Lake St. George Boating Facility Improvements
for the Department of Agriculture
Conservation & Forestry
Augusta, Maine

Addendum No. 1
September 7, 2016

Typical Paved Area Section

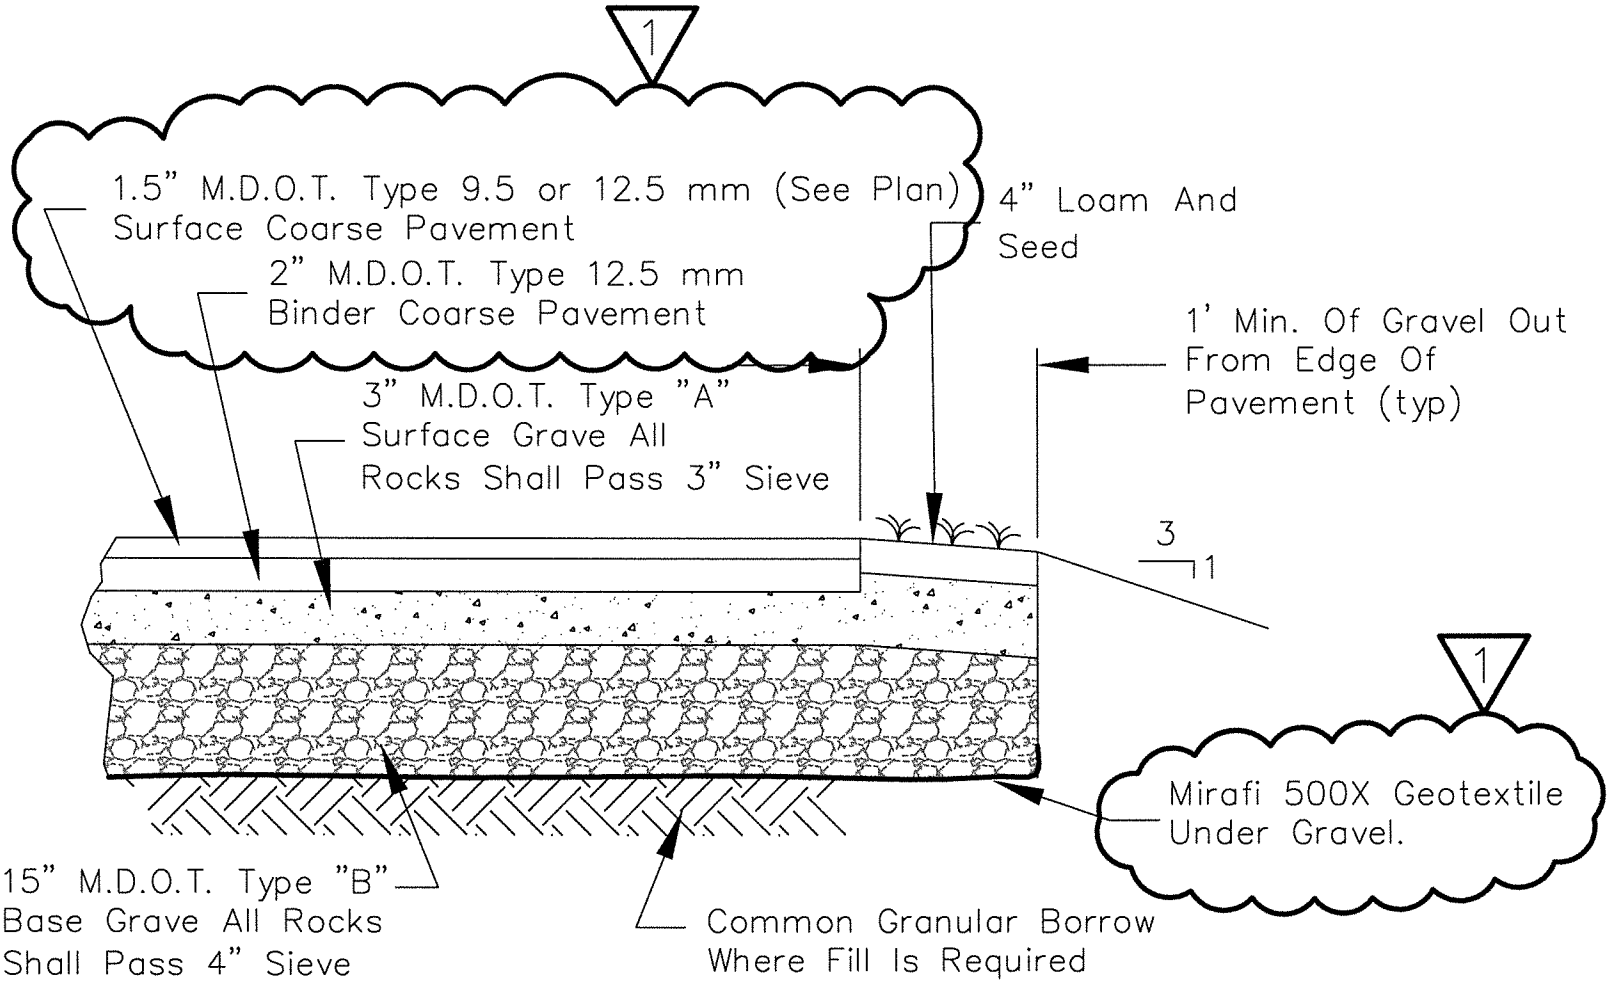
1. **Sheet 2 of 2 – Details - Typical Paved Area Section**: Please add Mirafi 500X geotextile under gravel, and the option of using 12.5 mm surface coarse pavement has been added (see attached detail).
